Addendum No. 4

Diablo Road Trail and Drainage Improvement Project Project No. C-055

SHEET NUMBER
17
OF 22 SHEETS
PROJECT NO.
8870.000.011

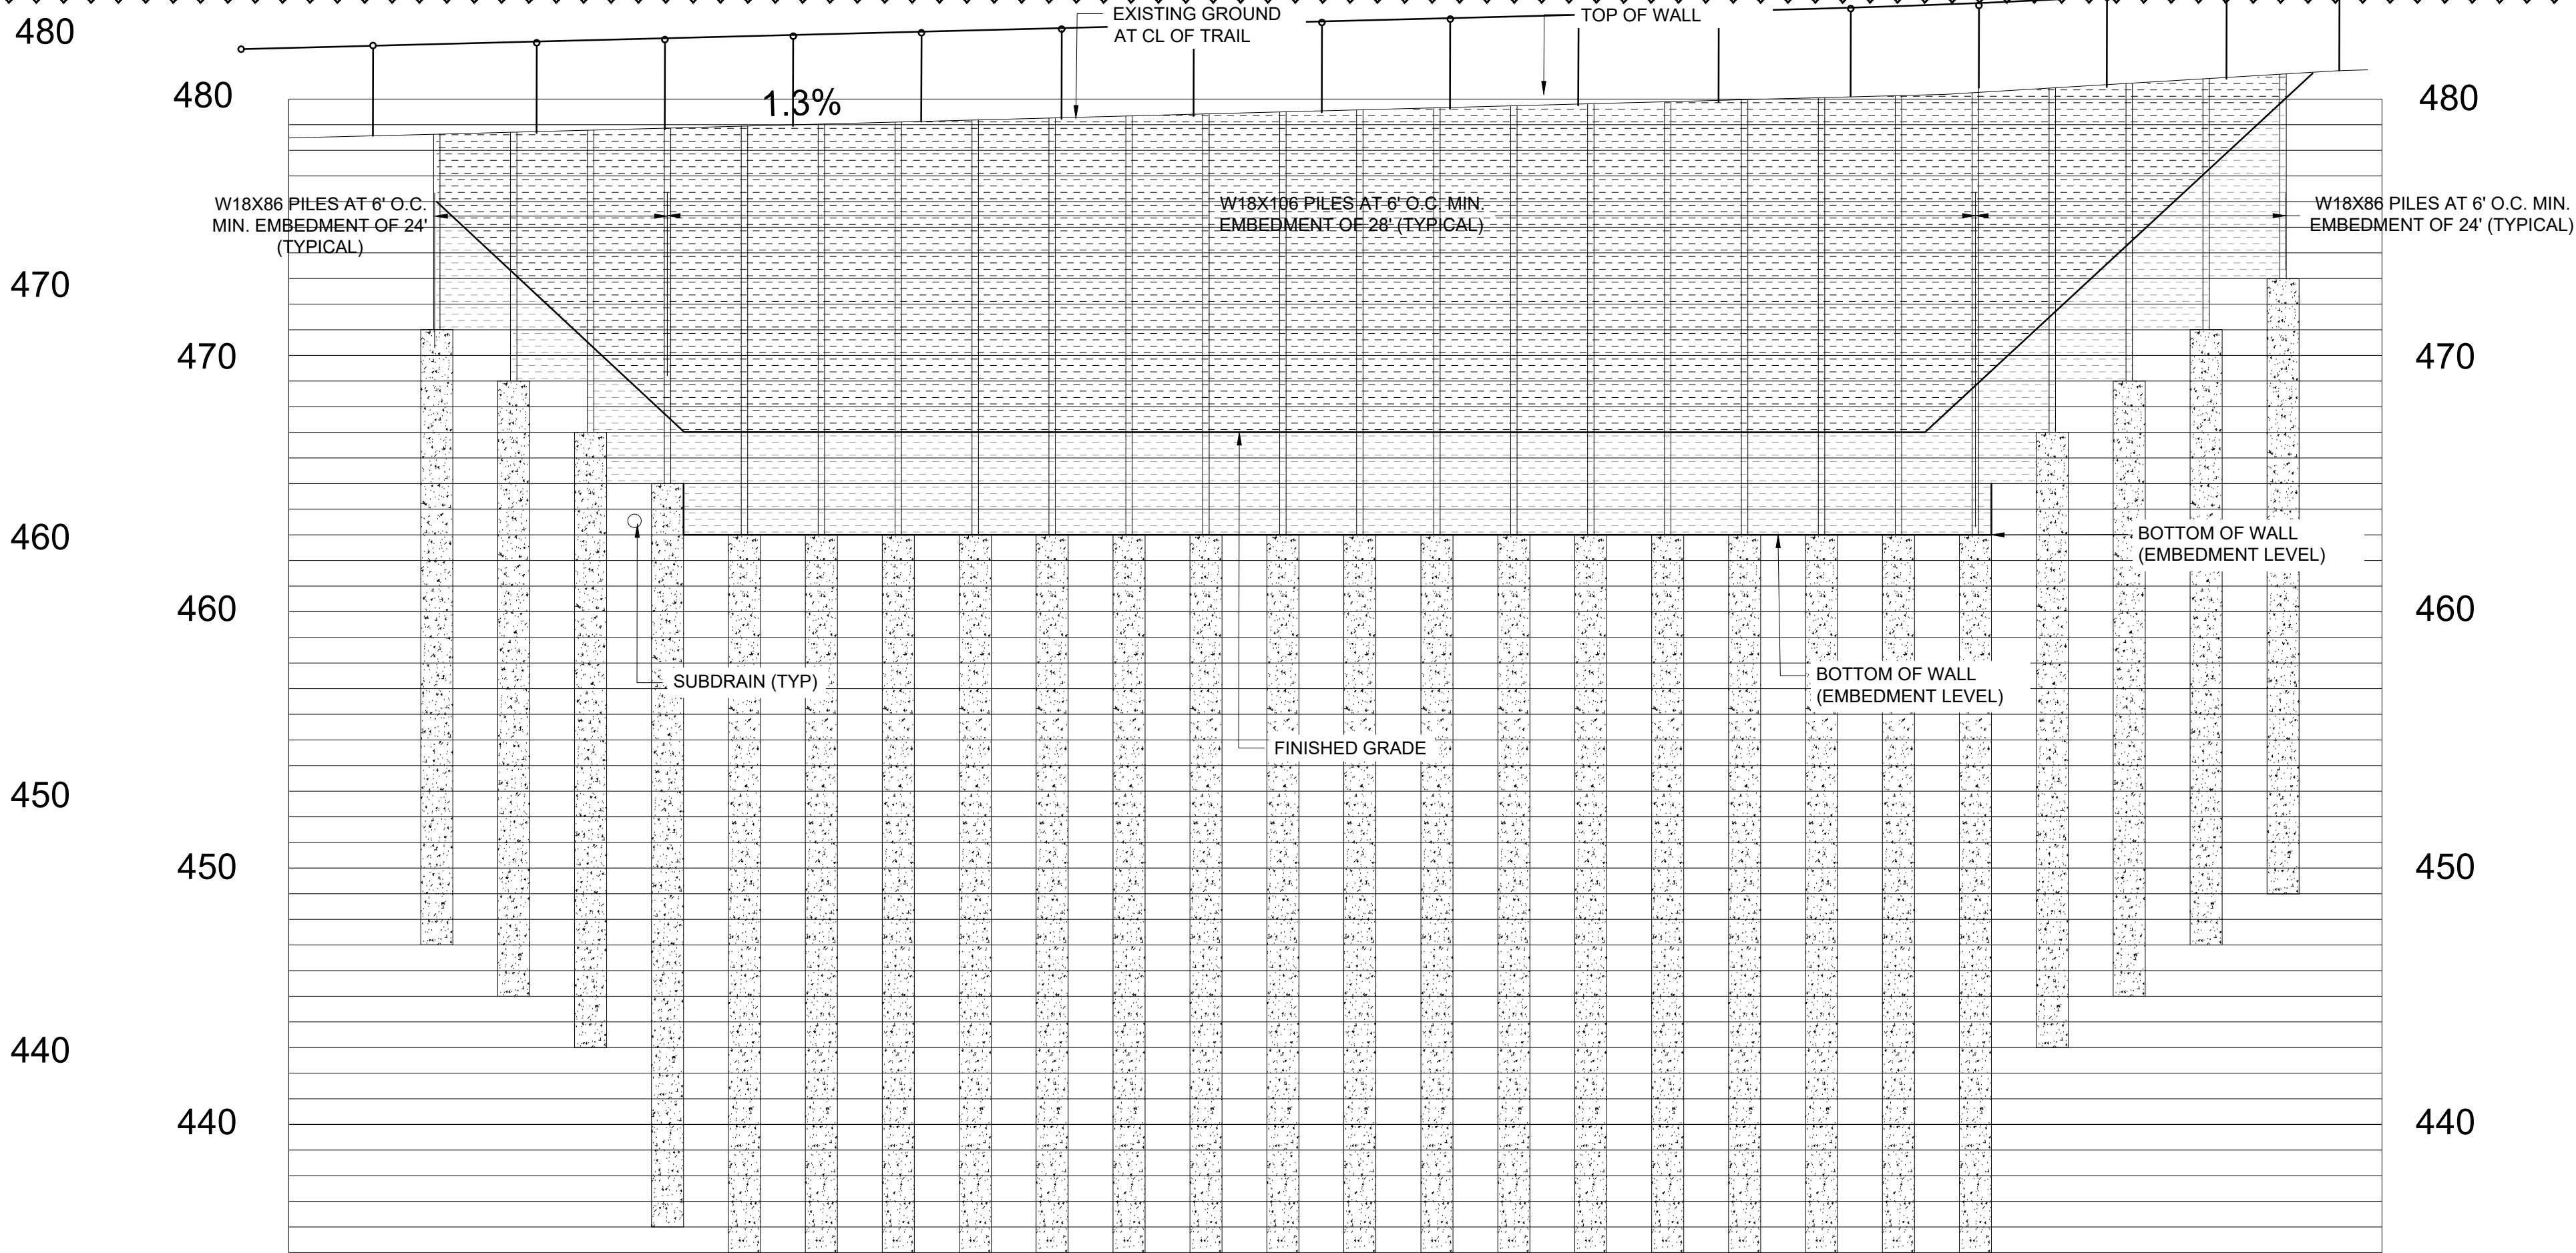
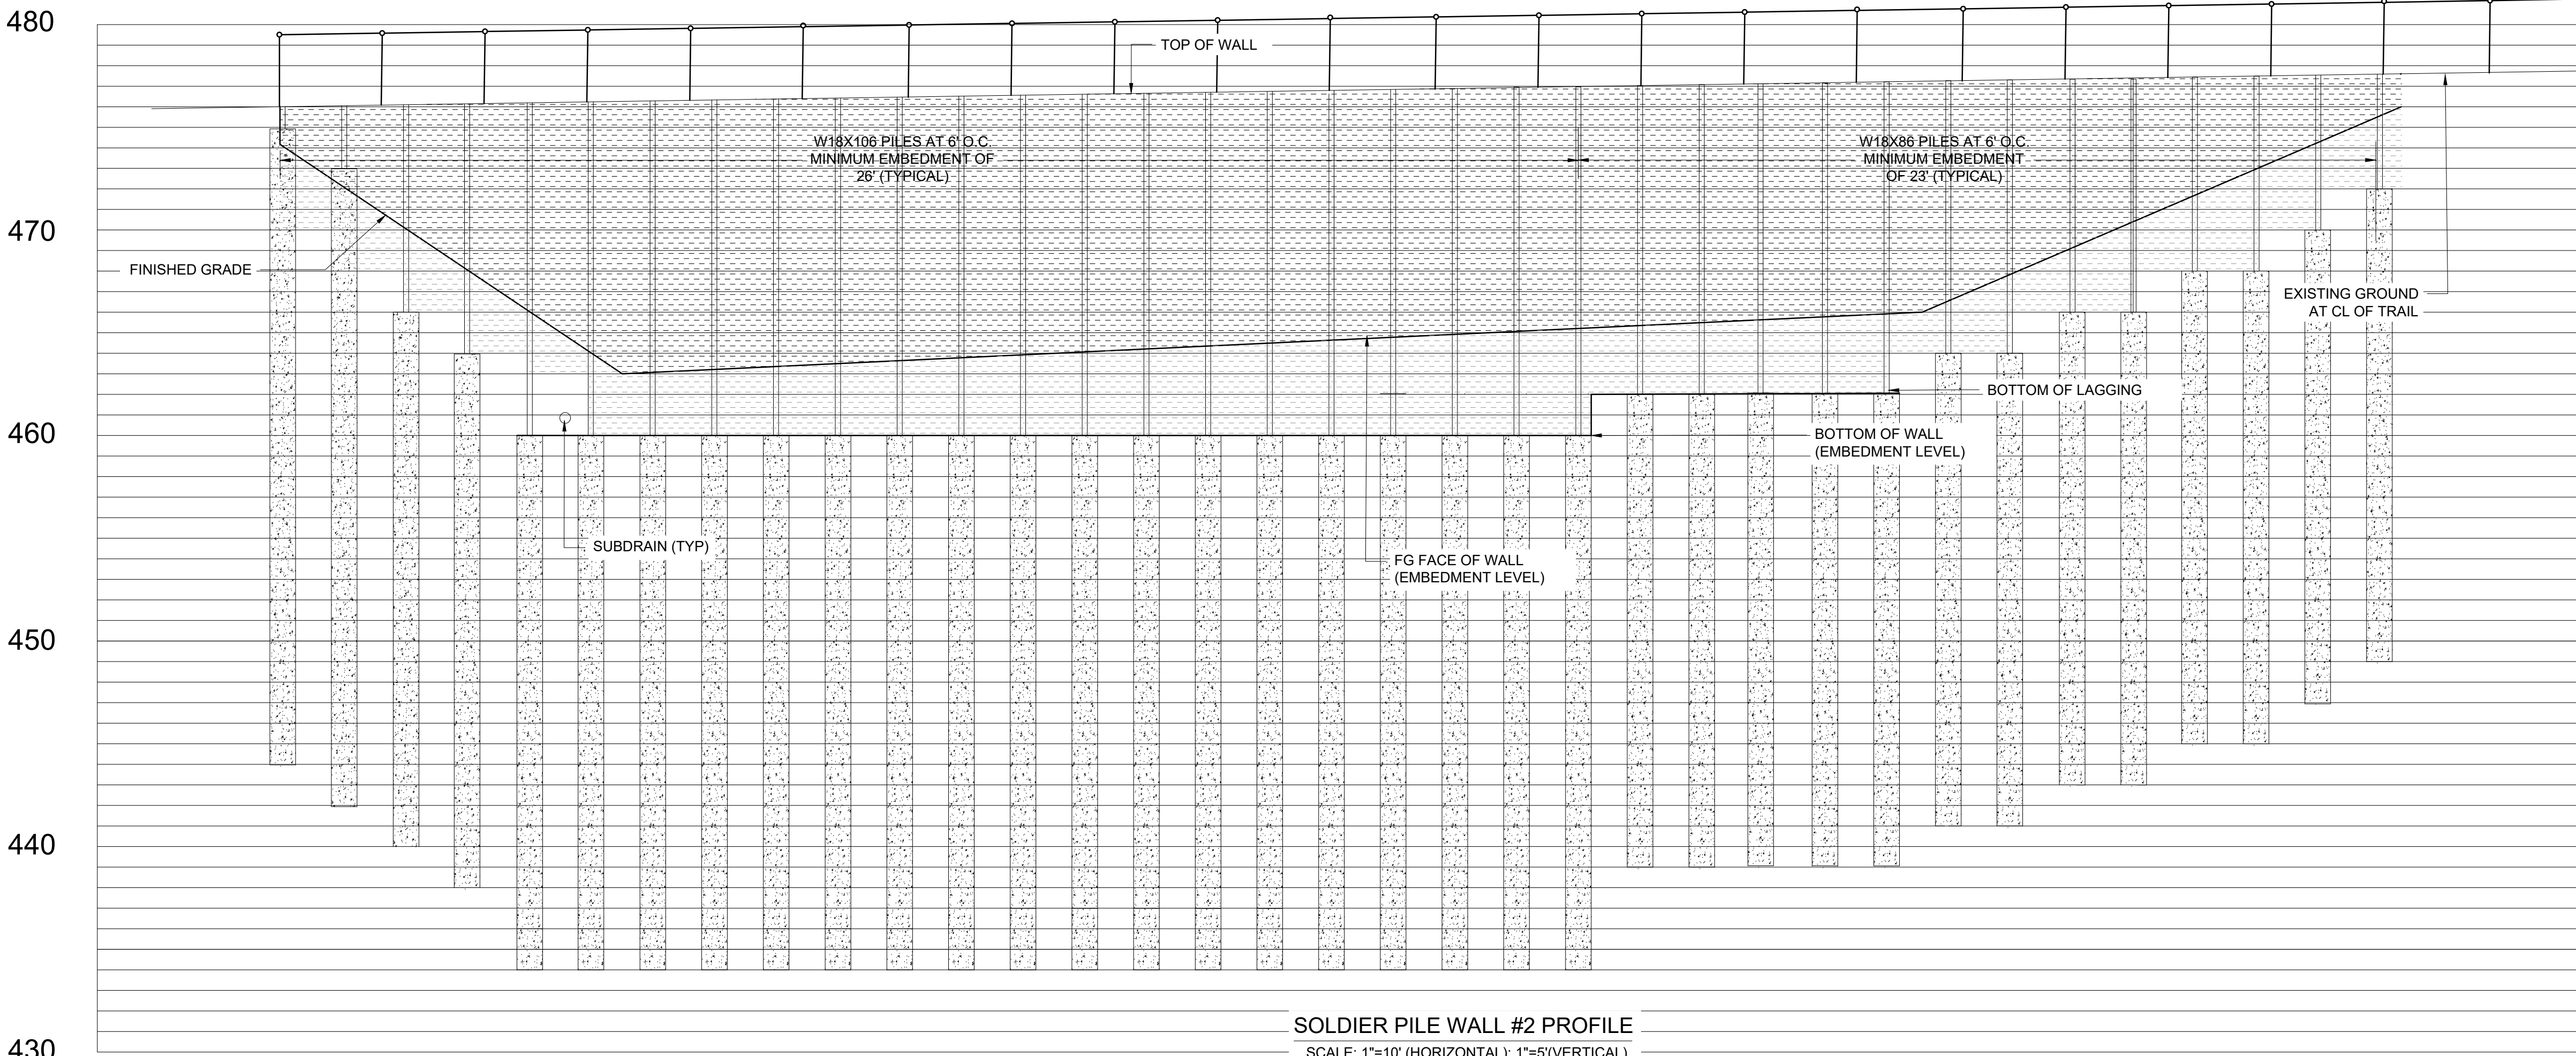
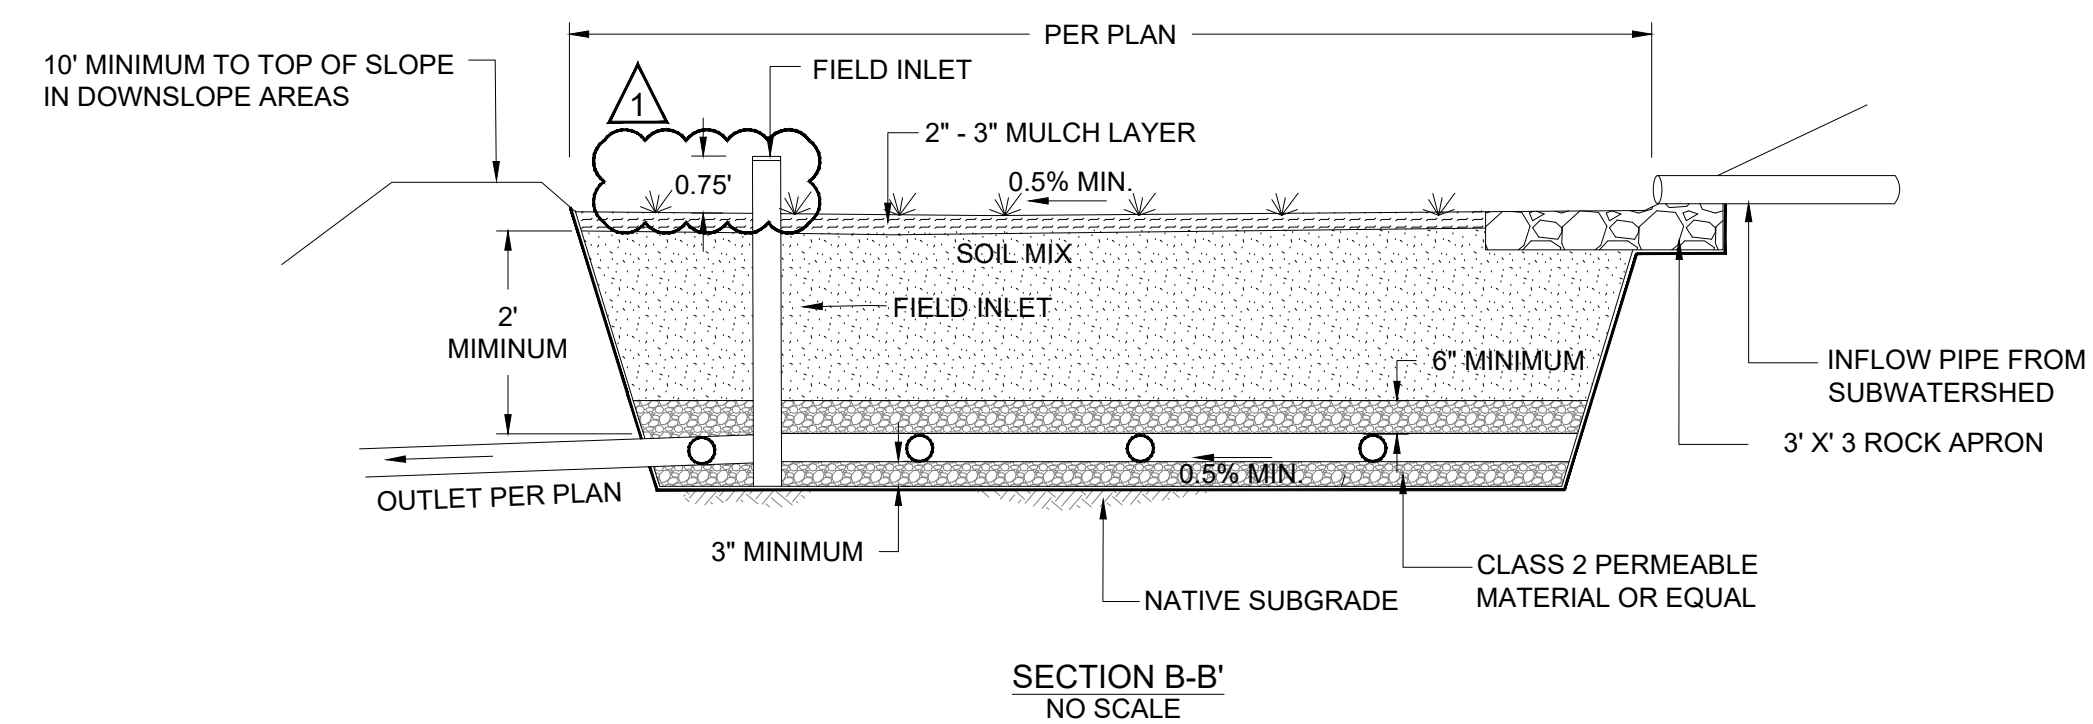
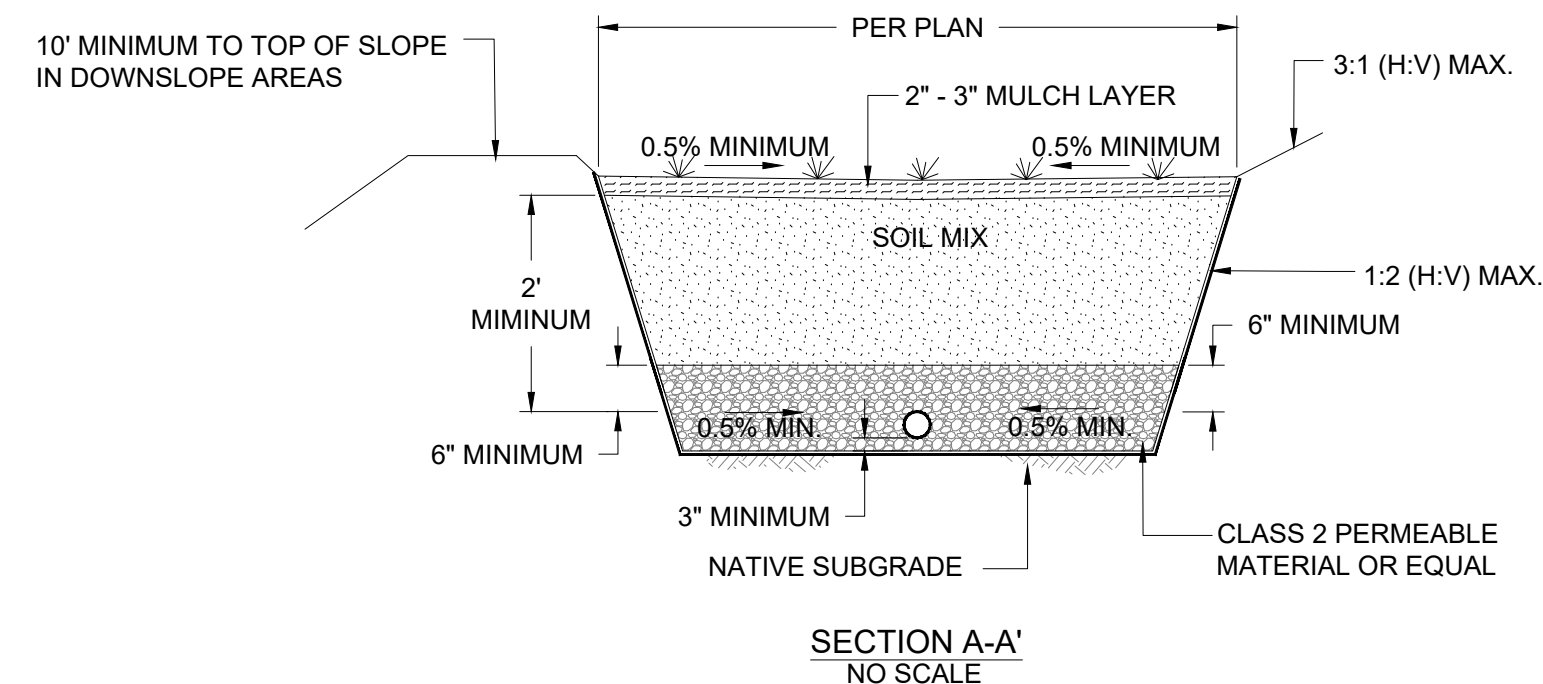
69- Soldier Pile Wall #2 (Plan Sheet 17) calls for W18x186 steel beams. These beams do not exist. Please confirm which steel beams are to be used in lieu of the W18x186 beams.

94-Profiles Shown on Sheet 17 show the Profiles for Soldier Pile Walls #1 - #3. All of them show the top of wall Precast Concrete Lagging matching the contour of the new path. Cutting the concrete lagging to match would be an arduous task. Could the City please consider a different design option for the top of Soldier Pile wall(s)?

- a. We have modified the top lagging section to reflect a timber lagging in Addendum 1.
